E-42425  
July 10, 2015

Subject: Competent Authority Certification (CAC), USA/0745/AF-96, Request for  
Additional Information for the Model ANF-50 Package

**EVALUATION****RAI-1 CRITICALITY/SAFETY**

Figure 1: Comparison of Pellet Box of the Assumptions of an Undamaged and Damaged Criticality Model

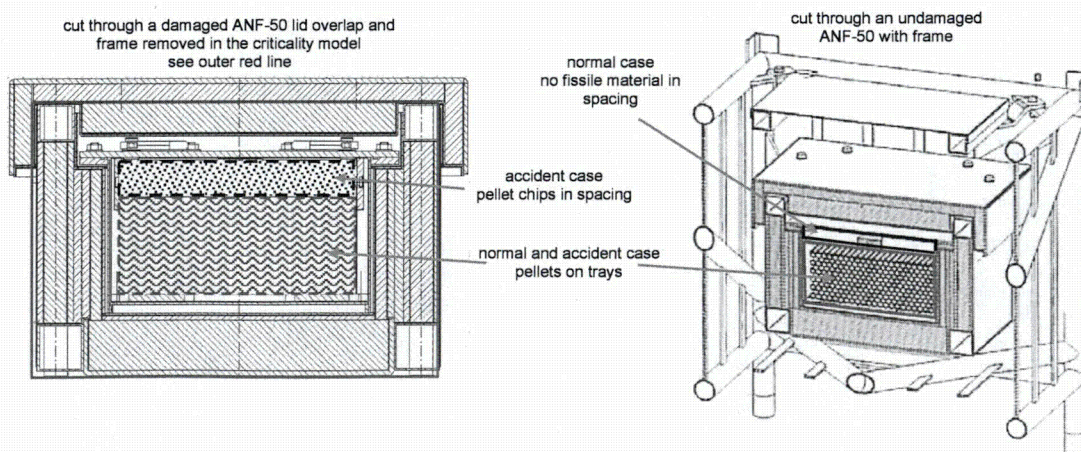
- a. the differences between the assumptions for the 2013 and 2015 criticality safety evaluation under hypothetical accident conditions (HAC) for Content No. 1 assuming exterior pellets are crushed and pellets enter the clamping area, and
- b. appropriateness of these changes in assumptions to adequately represent the package under HAC.

Figure 1 shows the first criticality models. On the right side of Figure 1, a cut of an undamaged ANF-50 is shown with pellets on trays. There is no fissile material in the clamping spacing. The left side shows the very conservative damaged criticality model. The dimensions of the pellet box before and after drop testing remains unchanged (see red line). The overhang of the lid and the reduced frame size (that leads to more spacing between the pellet boxes) were not included in the model. In the addendum criticality report the clamping spacing was filled with pellet chips.
